AMENDMENTS TO THE DRAWINGS:

U.S. Application Serial No.: 10/623,540 Attorney Docket No. 1015290-000661 Amendment Responsive to Office Action dated February 15, 2006 filed on May 12, 2006 Annotated Drawing Sheet 1 of 1

FIG. 10

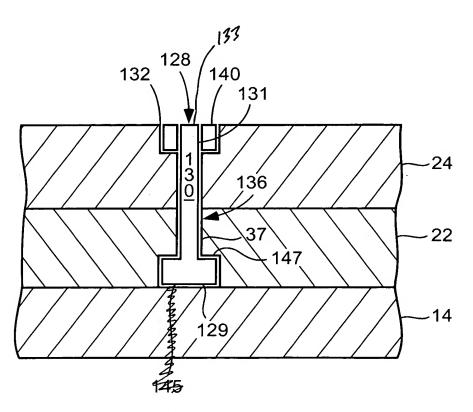
figures. In FIG. 10, reference number "133" and an associated lead line are added,

and reference number "145" and an associated lead line are deleted.

At numbered point (2) of the Official Action, it is asserted that reference character "131" has been used to designate the "upper portion," "threads" and "external threads." To address this objection, Applicants propose to amend Figure 10 to add the reference number 133 to indicate the location of the "upper portion." The specification is amended to be consistent with revised Figure 10.

At numbered point (4) of the Official Action, it is asserted that reference number 145 is not mentioned in the description. Applicants propose to amend

Figure 10 to delete reference number 145 and its associated lead line to address this objection. This amendment to Figure 10 also addresses the objection stated at numbered point (5) of the Official Action.
